Access Compliance Report

Public Rights-of-Way

Intersection ID: 5980	Main Street: SUTHER_RD	Cross Street: MARGIE_ANN_DR	Location: E
ADA ID: 1818F5785C5E	Ramp Type: PerpDiag	Initial Pass/Fail: Fail	Overall Compliance: No
Severity Score: 12.5			
Codes/Mitigation Info/Possible Solution		Field Measurements/Component Compliance

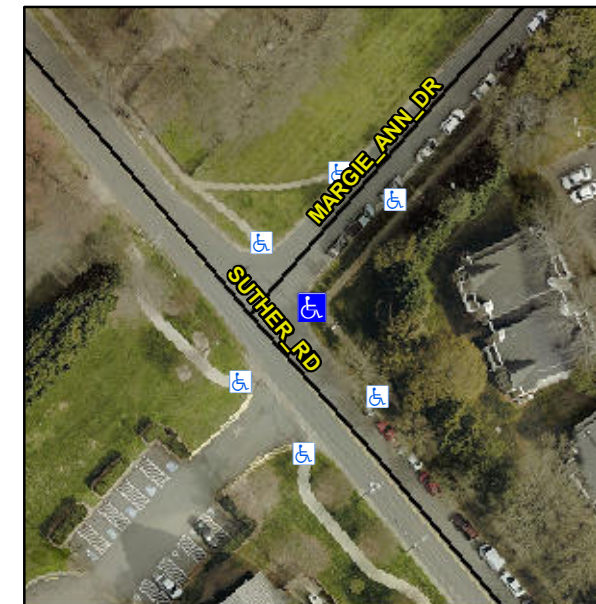
Not Found, R304.5.3

Compliance	Description	Data	Compliance	Description	Data
N/A	Ramp Length (in)	58.0	Yes	Ramp Slope (%)	8.1
Yes	Ramp Width (in)	53.0	No	Ramp XSlope (%)	6.4
N/A	Flare Type LT	N/A	N/A	Flare Type RT	N/A
N/A	Flare Slope LT (%)	N/A	N/A	Flare Slope RT (%)	N/A
N/A	Flare Traversable LT?	N/A	N/A	Flare Traversable RT?	N/A
N/A	Landing Length (in)	N/A	N/A	DWS Provided?	N/A
N/A	Landing Width (in)	N/A	N/A	DWS Contrast?	N/A
N/A	Landing Slope (%)	N/A	N/A	DWS Length (in)	N/A
N/A	Landing X Slope (%)	N/A	N/A	DWS Full Width?	N/A
N/A	Landing Curb? (Y/N)	N/A	N/A	DWS Offset (in)	N/A
N/A	Shared Landing?	N/A			
N/A	Gutter Ponding?	N/A	N/A	Gutter Slope (%)	N/A
N/A	Gutter Lip Ht (in)	N/A	N/A	Gutter X Slope (%)	N/A
N/A	Painted X Walk1?	No	N/A	Painted X Walk2?	No
	X Walk 1 Direction	To NW		X Walk 2 Direction	To SW
N/A	X Walk 1 Width (in)	N/A	N/A	X Walk 2 Width (in)	N/A
	X Walk 1 Slope (%)	2.2		X Walk 2 Slope (%)	5.7
	X Walk 1 X Slope (%)	4.2		X Walk 2 X Slope (%)	0.6

Remove & Replace Curb Ramp With Two New Directional Ramps or Equivalent.
